Additional features needed in RAP

K.Weber

Clause 1 (concept and context of RAP – should be replaced)

Figure
Does not show
Real Numbers!

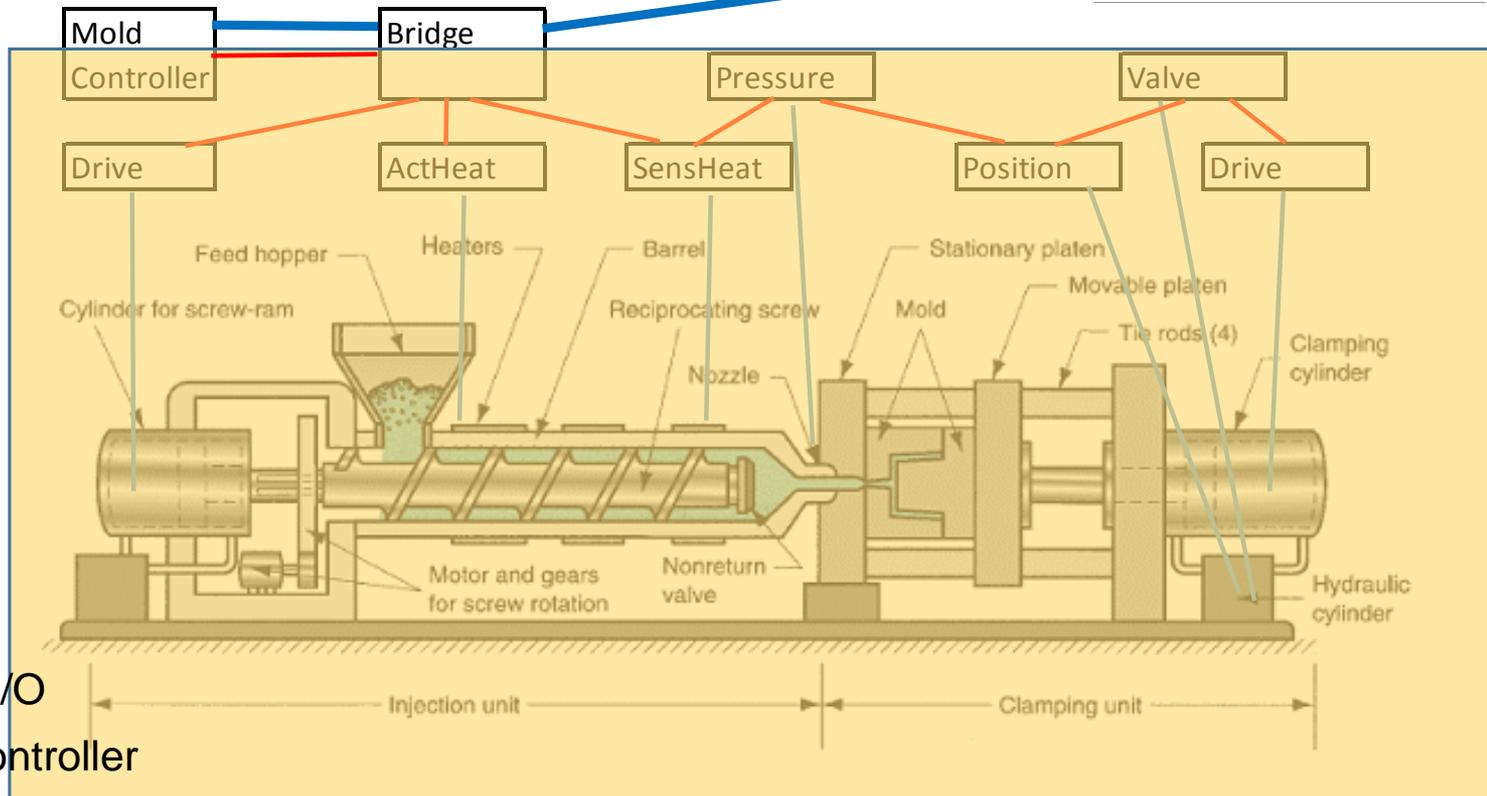
- Focus should be RAP and not the comparison with CNC
the relationship to CNC and scheduled traffic should be explained in a short section.
 - Figure 1 should be a little bit modified to avoid overlap of different use of single terms
- Suggest to redesign clause 1, pointing out the complexity of a totally flat model in a structured environment (this is related to any kind of approach discussed as of now)
